**TOWN OF CARMEL**  
**ENVIRONMENTAL CONSERVATION BOARD**

**ENVIRONMENTAL CONSERVATION BOARD AGENDA**

**NOVEMEBER 2, 2017 – 7:30 P.M.**

# CARMEL CENTRE SENIOR HOUSING CARMEL CORPORATE CENTER LOT #5

PLANT LIST FOR MITIGATION PLANTINGS.

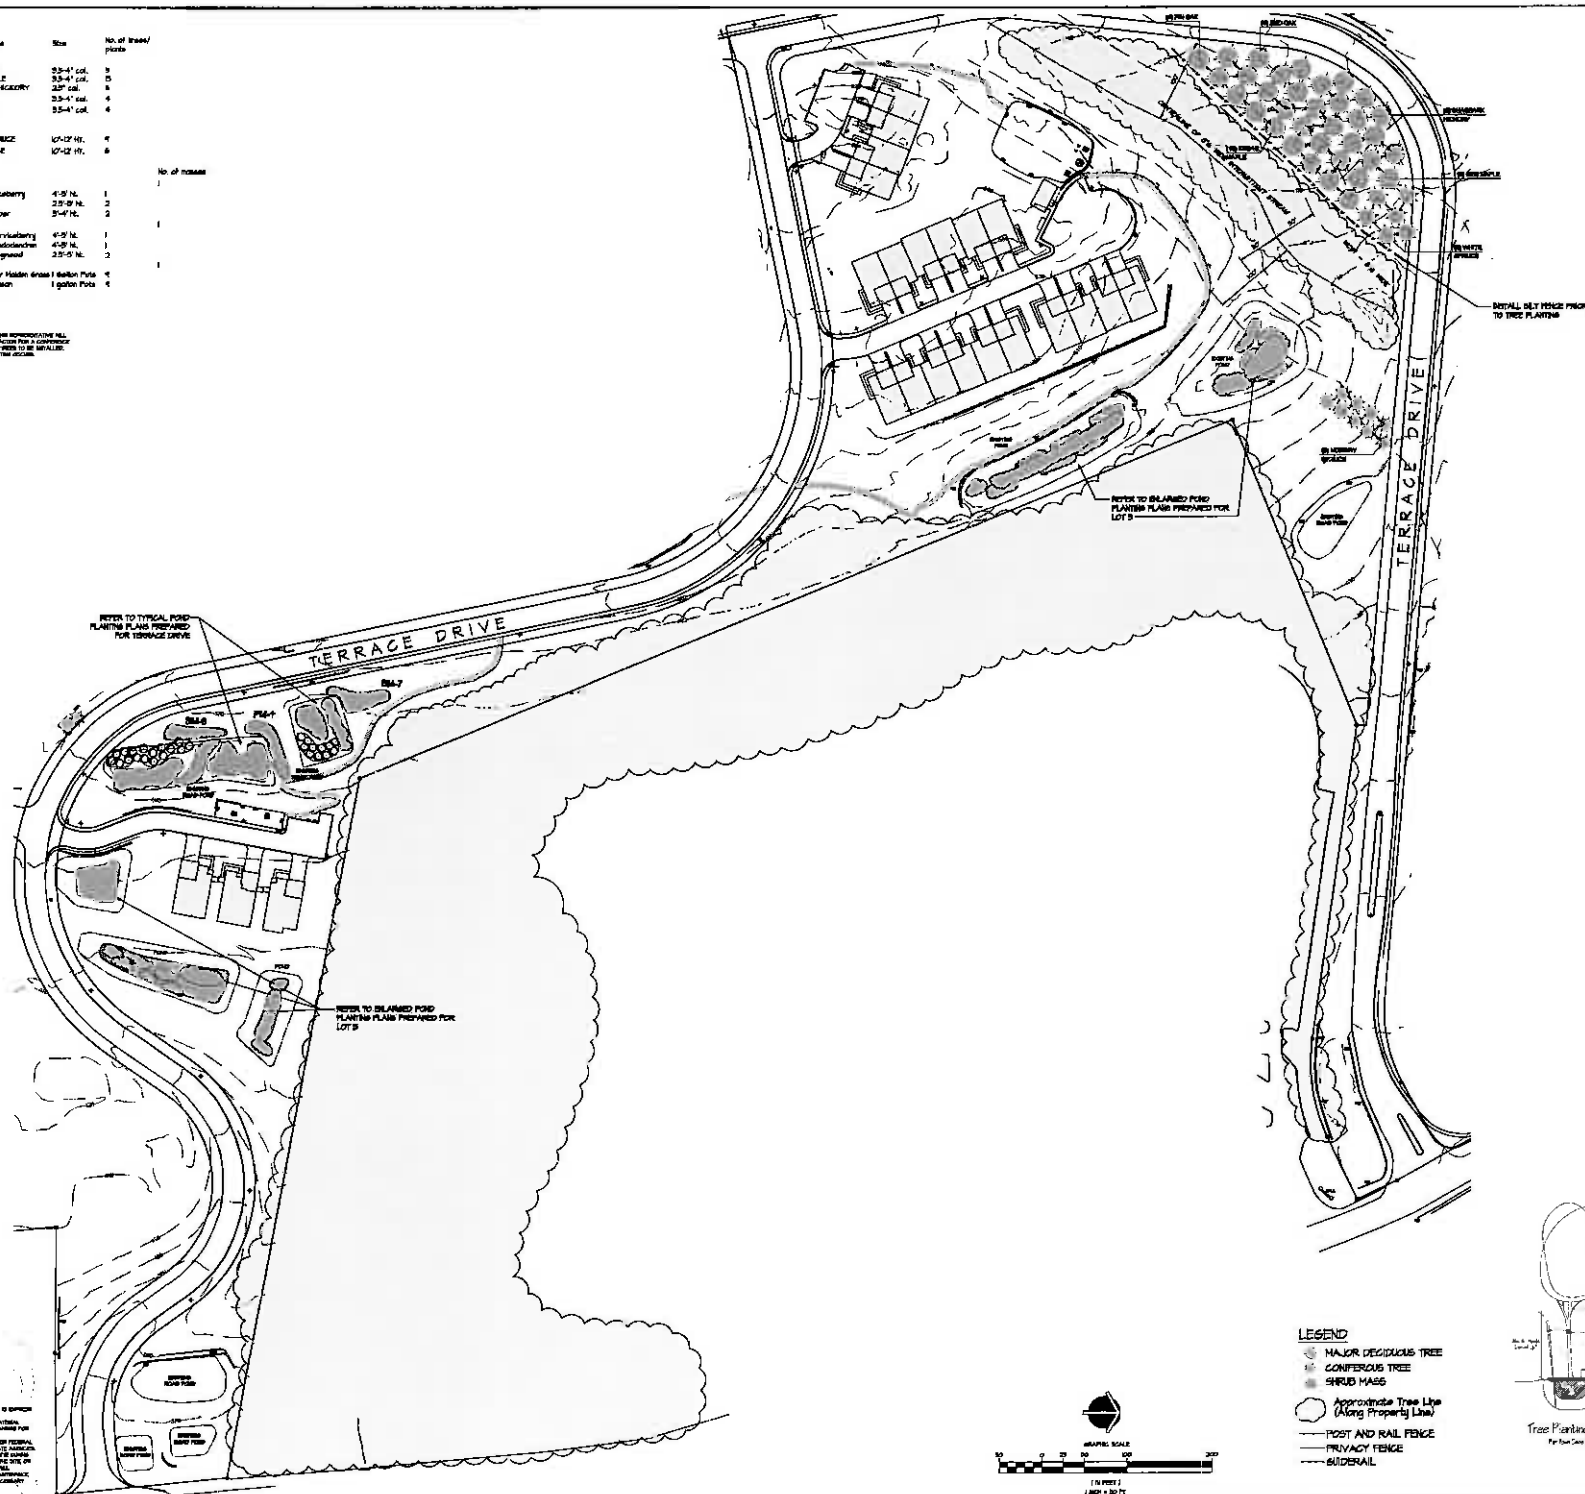
Upon Surveying property in  
Question: we have concluded that all  
trees on this List are compatible for  
Area and Zone, with the exception of the  
White Spruce which is Not Native to this  
planting Zone.

Therefore our Recommendation  
will be to replace with a Norway Spruce.
